Exhibit C

**Subject: Aesthetic Flow Adequacy Plan – Article 403
St. Anthony Falls Hydro (FERC Project No. 2056)**

Northern States Power Company – Minnesota, d/b/a Xcel Energy, licensee for the St. Anthony Falls Hydro Project No. 2056 (“Project”), is filing for your review as Attachment A the initial Public Perception Survey Report (“Survey Report”) regarding minimum flows at the Project’s main spillway. The Public Perception Survey (“Survey”) was conducted pursuant to license Article 403 (*Aesthetic Flow Adequacy Plan*) of the Project license, 106 FERC ¶ 62,185 (2004), and the Survey Report, including responses to stakeholder consultation, is required to be filed no later than March 30, 2017, pursuant to a letter order issued by the Commission on May 18, 2015, in the above-captioned docket.

Figure 2-13 Distribution of Ratings for Range of Flow Levels (100–2,000 cfs): All Respondents

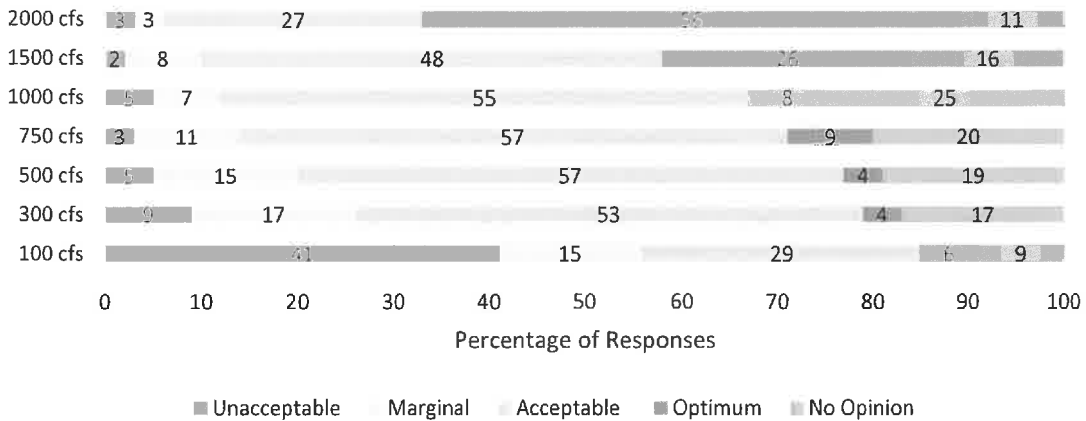
- Figure 2.13 of the Survey Report shows that 53% of all respondents feel that 300 cfs is an "acceptable" flow. This figure does not change appreciably for higher flows up to 1,500 cfs (see table below). The results are also similar for the optimum category where there is little variation (6% - 9%) for flows between 100 cfs and 1,000 cfs. Thus, the number of additional respondents that would be satisfied with a minimum flow requirement greater than 300 cfs does not justify the incremental loss in generation. Again, the potential impacts to A-Mill and Crown must also be considered.

2.9.8 2,000 cfs (Photo 2)

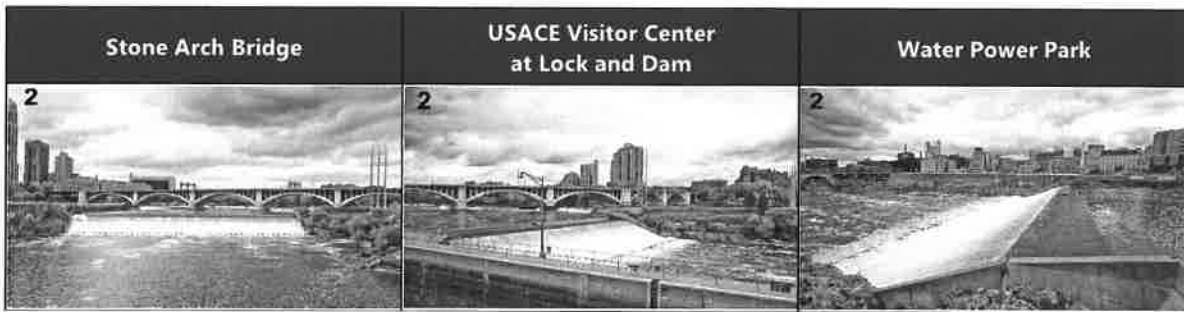
- Section 2.9 addresses the General Summary of Photo Ratings (Page 18). I know from our discussions there may have been some issues with the photos. Regarding the 2,000 cfs photo, this appears to be the same photo as shown for the USACE Visitor Center and for Water Power Park. The correct photo(s) should be used in the report. The discussion throughout this section and in the photos (Pages 14 to 19) uses non-objective terms or phrases which in some cases do not correlate with the information from the surveys. Objective descriptions and evaluations should be used. These include: (1) Nine to 25% who chose the response do-not care/no opinion is not a “fairly significant number of participants” (Section 2.9.1); (2) “only 5% considered” and “only 3% found” 500 cfs and 750 cfs unacceptable (Section 2.9.4 and Section 2.9.5); (3) “surprising 21%” of respondents and “only 12% found it” unacceptable (Section 2.9.6); and (4) “only 10% found” the flow unacceptable (Section 2.9.7).

Section 2.9.1 has been revised to use objective descriptions and evaluations. The photo of 2,000 cfs for Water Power Park under Section 2.9.8 has been corrected.

Figure 2-16 Waterfall Flow during Survey Period

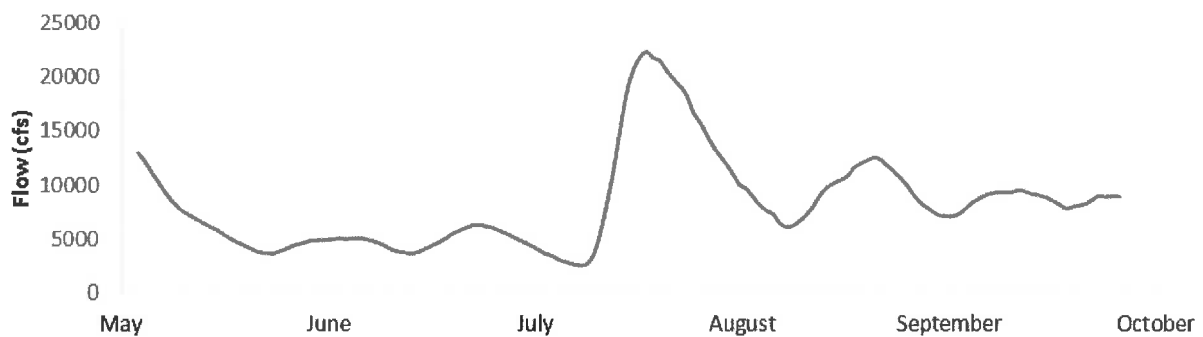
- I suggest displaying what the river flow was on the days that the surveys were taken (although the report notes that it was 2,000-25,000 cfs). It is unfortunate that the actual flow in the river was not as low as in some of the photographs, so you could correlate the responses to your 10th question to the responses given to the photographs.

- Survey data appears to have been collected in locations where respondents would have a clear view of the Falls, which suggests that a correlation between a response and the flow condition might exist and be revealing as a part of the conclusions presented in the report. While flows are noted in the report being as much as 25,000 cfs on some survey dates, there is no correlation between actual flows and collected survey data. Without this correlation, there could be a tendency for responses to reflect actual flow conditions as opposed to those demonstrated by the images of the flow scenarios.

Licensee has included a graph (Figure 2-16) in the report depicting the approximate flow at the main spillway throughout the survey period. Licensee notes that pursuant to Article 403 of the license, photographs of a range of flows between 100 cfs and 2,000 cfs over the spillway were required to be taken, based on FERC staff's recommendation in the environmental assessment that licensee monitor and document flows over the spillway sufficient to result in flows ranging between 100 cfs and 2,000 cfs over the spillway. See License at ¶ 46. Because the flows over the spillway for all days in which interviews were conducted was greater than 2,000 cfs, flow information correlated to the survey date would not have provided additional information relevant to the Commission's determination whether to increase the minimum aesthetic flow to more than 100 cfs.

The survey locations, specifically selected to have a clear view of the waterfall, were approved by all stakeholders, including the MPRB. Licensee has included a graph (Figure 2-16) in the report depicting the approximate flow at the main spillway throughout the survey period. The value of developing a correlation between actual flow conditions and the results of the survey is unclear as licensee has no control over natural river flows.
